Subject: PC 10-2025: City of Manitowoc / Tycore; Preliminary Subdivision Plat,

Public Improvements Plan & Certified Survey Map. Former Mall Properties / Mariner Lux Development (Parcel #'s 330-008-152, 520-

MARINER LUX SUBDIVISION PLAT

PRELIMINARY PLAT CONDITIONS Mariner Lux / Tycore PC 10-2025 3/13/2025

- A PRELIMINARY PLAT OF -NARINER LUX SUBDIVISION PLAT TYCORE BUILT

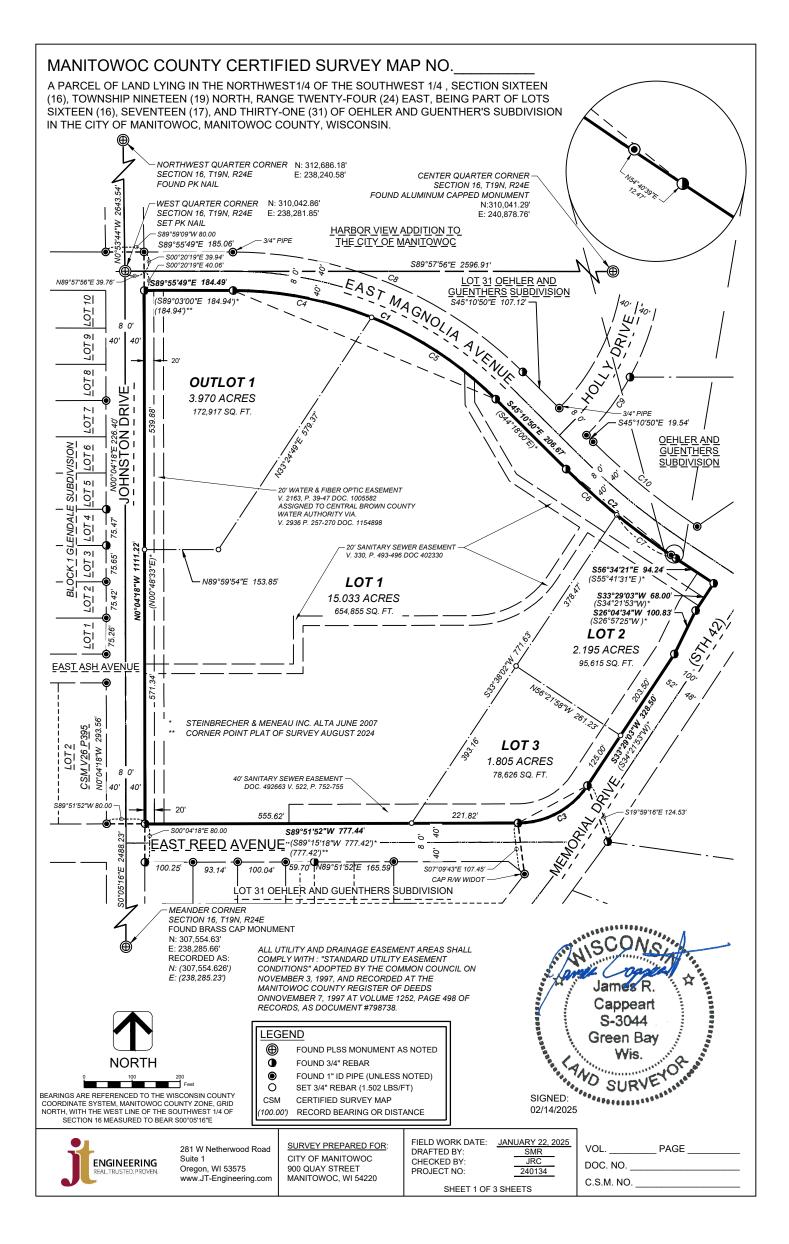
- k. Additional landscaping/beautification features, if desired by the developer, shall also be reviewed by the City.
- I. Galax Court should be constructed 32 feet wide with a 60-foot-wide ROW. The Cul-de-sac shall be built per the City of Manitowoc's Standard Specification Form #518. The Subdivision Plat shall also reflect the Right-of-Way as it pertains to this form.

- e. MPU Water: C200 plan drawing, proposed apartment complexes look to be too close to existing CBCWA watermain easement. Show easement on plan drawings. Contact MPU water to discuss 920-683-4600.

- g. Existing watermain(s) are not shown properly on utility plans, particularly existing 16" watermain on E Magnolia Ave.
- h. Parallel watermains are not acceptable. Proposed watermain on Fern Drive should connect to existing stubout at Fern/E Linden intersection. 6" watermains are not acceptable. For MPU to consider 6" watermains, a hydraulic model is required to ensure adequate fire flow protection. 6' bury depth of watermains is typical. Hydrant on Galax Court should be on lot line.

a. We don't think the Galax Court is the proper name for the road, as it is disconnected from Galax Street. We feel this may cause problems for rescue service and delivery services. To be consistent with other street name themes in this part of the City the City is suggesting Galax Court be renamed to Juniper Court.

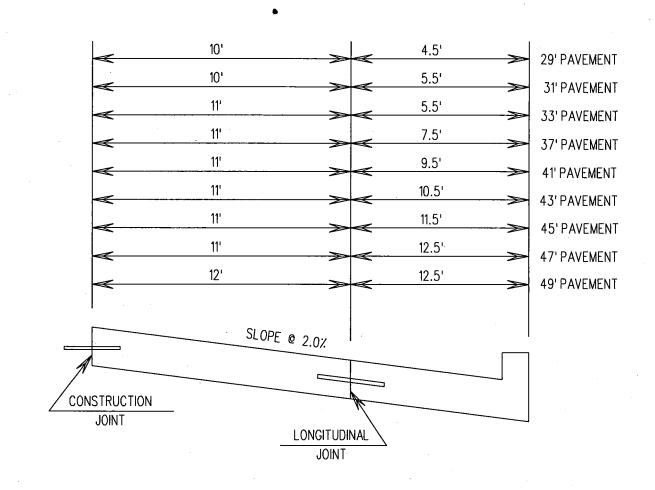
- i. See map provided by MPU
- j. Watermain plans are not approved by MPU.
- k. Contact MPU regarding electric service requirements, potential street lighting, and cost estimates for electrical installation. MPU will send B-Forms to other utilities that would like to utilize joint-trench where applicable. Contact Justin Hoffmann (920)686-4347.

CONCRETE PAVEMENT JOINT DETAIL (INTEGRAL CURB)

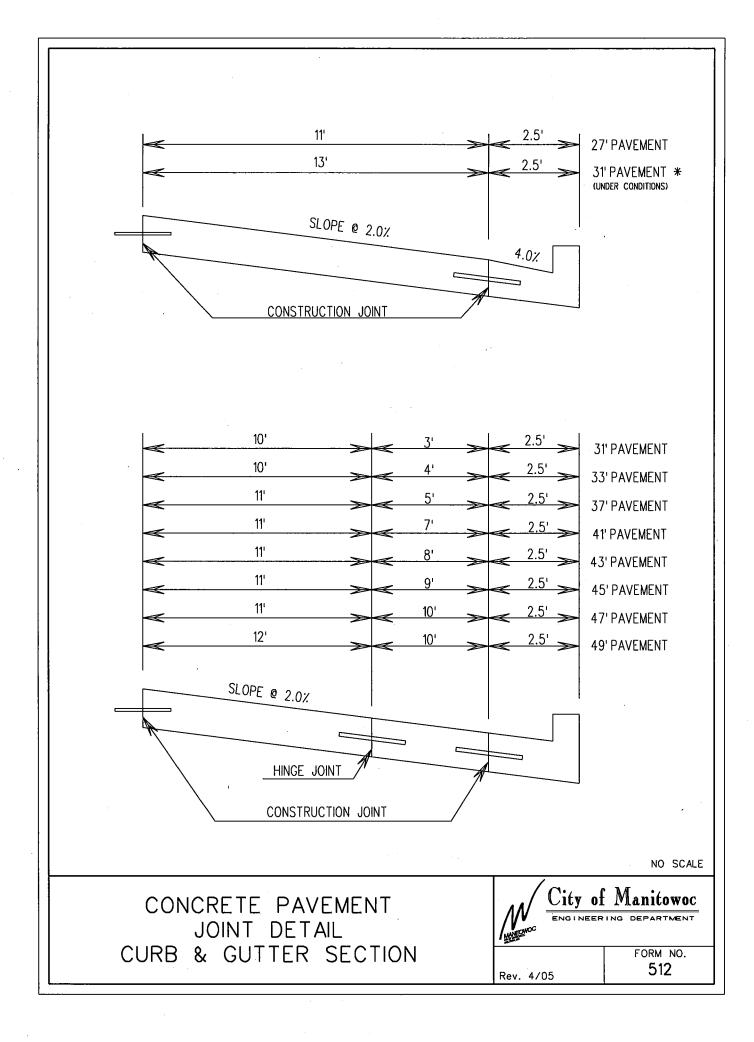
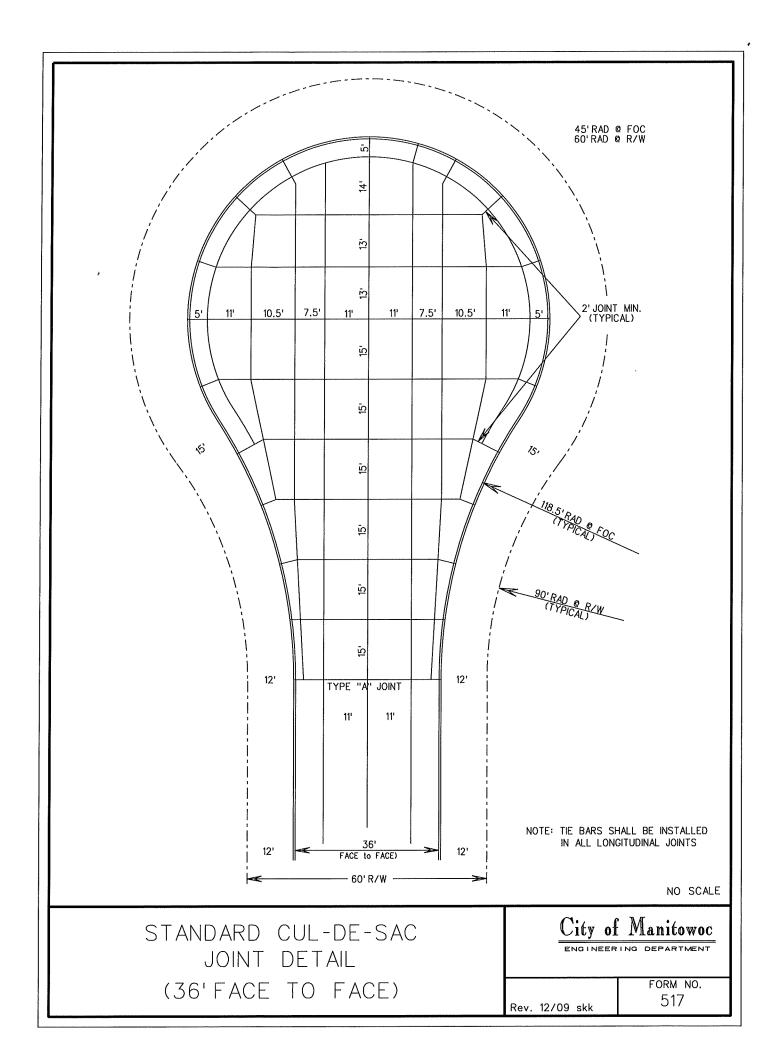
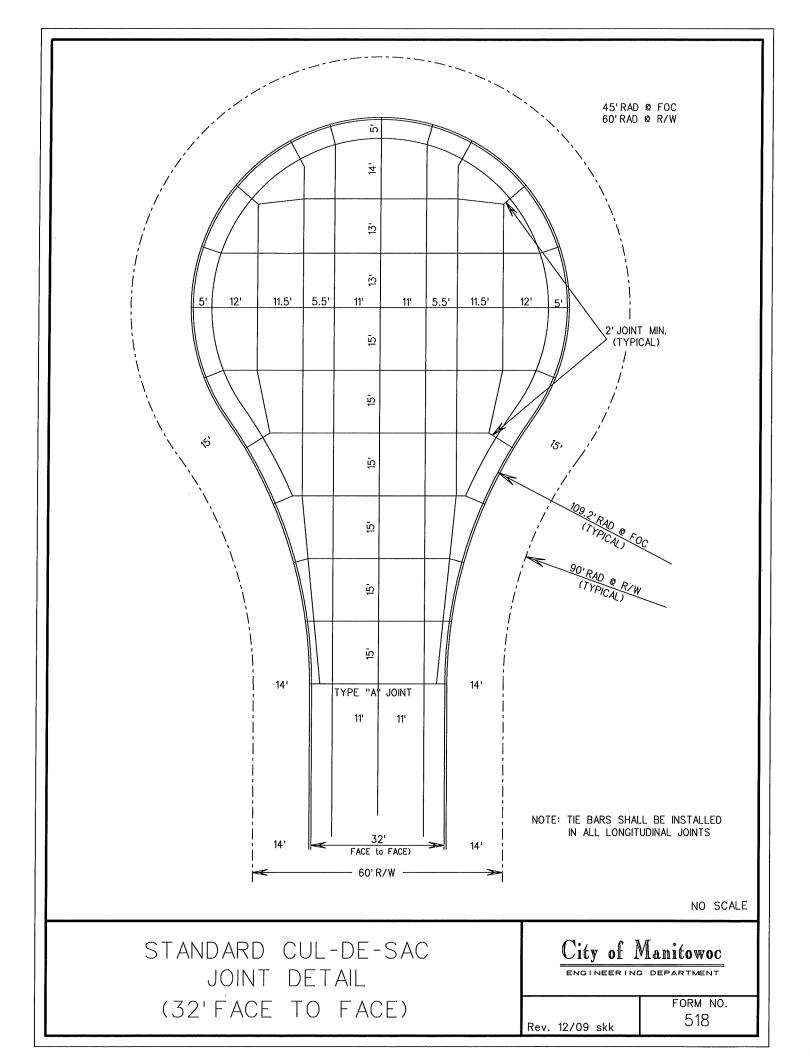
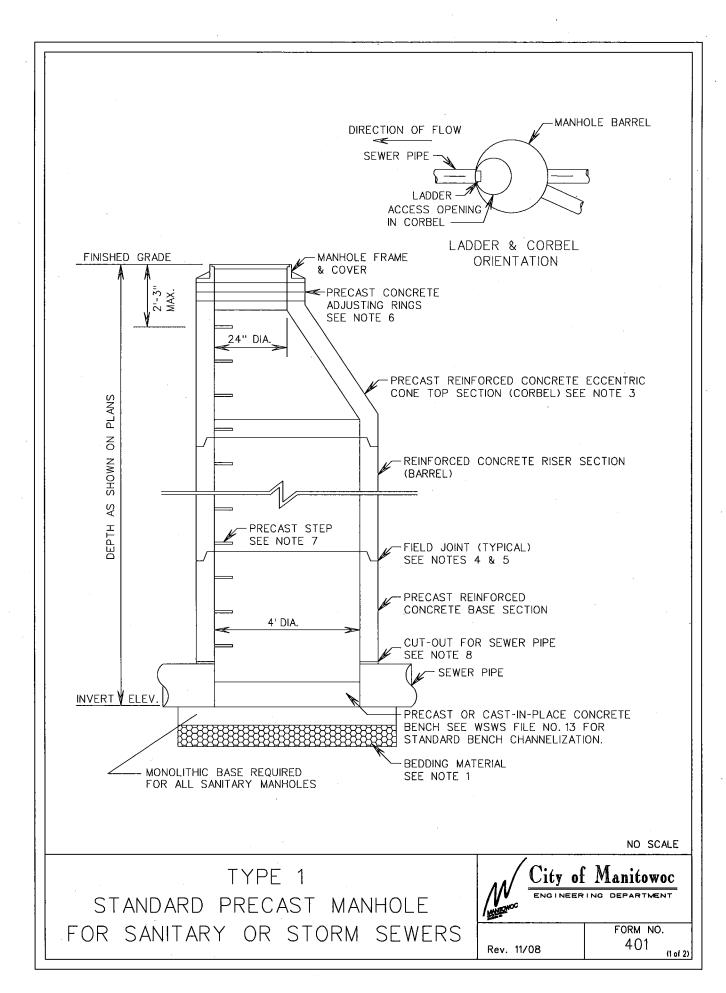
- p. All new concrete pavement shall be constructed with integral curb on both Fern Dr. and Galax Ct. as per 511.12 of Manitowoc Standard Specifications for Public Works Construction.
